## Product Change Notice (PCN)

PCN Number: **PCN-0450524R-01**

Product(s) Affected: *SJ-2523-SMT-TR, SJ-2524-SMT-TR*

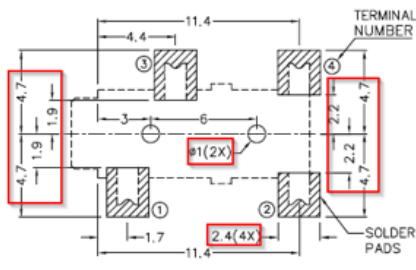
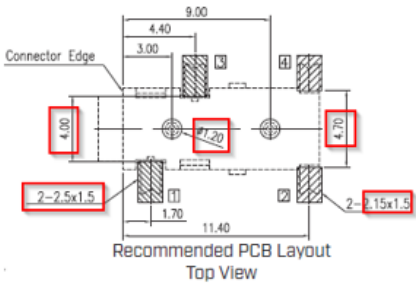
Reason(s) for Change: *Manufacturing process improvements*

Description of Change: *See below images*

PREVIOUS CUI DEVICES DETAIL / IMAGE	NEW CUI DEVICES DETAIL / IMAGE																																				
 <p>Recommended PCB Layout Top View</p>	 <p>Recommended PCB Layout Top View</p>																																				
<table border="1"> <thead> <tr> <th></th> <th>MATERIAL</th> <th>PLATING</th> </tr> </thead> <tbody> <tr> <td>terminal 1</td> <td>copper alloy</td> <td>silver</td> </tr> <tr> <td>terminal 2</td> <td>copper alloy</td> <td>silver</td> </tr> <tr> <td>terminal 3</td> <td>copper alloy</td> <td>silver</td> </tr> <tr> <td>terminal 4</td> <td>brass</td> <td>silver</td> </tr> <tr> <td>plastic</td> <td>PA6T or equivalent</td> <td></td> </tr> </tbody> </table>		MATERIAL	PLATING	terminal 1	copper alloy	silver	terminal 2	copper alloy	silver	terminal 3	copper alloy	silver	terminal 4	brass	silver	plastic	PA6T or equivalent		<table border="1"> <thead> <tr> <th>DESCRIPTION</th> <th>MATERIAL</th> <th>PLATING/COLOR</th> </tr> </thead> <tbody> <tr> <td>terminal 1</td> <td>phosphor bronze t=0.25</td> <td>silver over nickel</td> </tr> <tr> <td>terminal 2</td> <td>phosphor bronze t=0.30</td> <td>silver over nickel</td> </tr> <tr> <td>terminal 3</td> <td>phosphor bronze t=0.25</td> <td>silver over nickel</td> </tr> <tr> <td>terminal 4</td> <td>brass t=0.30</td> <td>silver over nickel</td> </tr> <tr> <td>housing</td> <td>PA10T (UL94V-0)</td> <td>black</td> </tr> </tbody> </table>	DESCRIPTION	MATERIAL	PLATING/COLOR	terminal 1	phosphor bronze t=0.25	silver over nickel	terminal 2	phosphor bronze t=0.30	silver over nickel	terminal 3	phosphor bronze t=0.25	silver over nickel	terminal 4	brass t=0.30	silver over nickel	housing	PA10T (UL94V-0)	black

MATERIAL	PLATING																																			
terminal 1	copper alloy	silver																																			
terminal 2	copper alloy	silver																																			
terminal 3	copper alloy	silver																																			
terminal 4	brass	silver																																			
plastic	PA6T or equivalent																																				
DESCRIPTION	MATERIAL	PLATING/COLOR																																			
terminal 1	phosphor bronze t=0.25	silver over nickel																																			
terminal 2	phosphor bronze t=0.30	silver over nickel																																			
terminal 3	phosphor bronze t=0.25	silver over nickel																																			
terminal 4	brass t=0.30	silver over nickel																																			
housing	PA10T (UL94V-0)	black
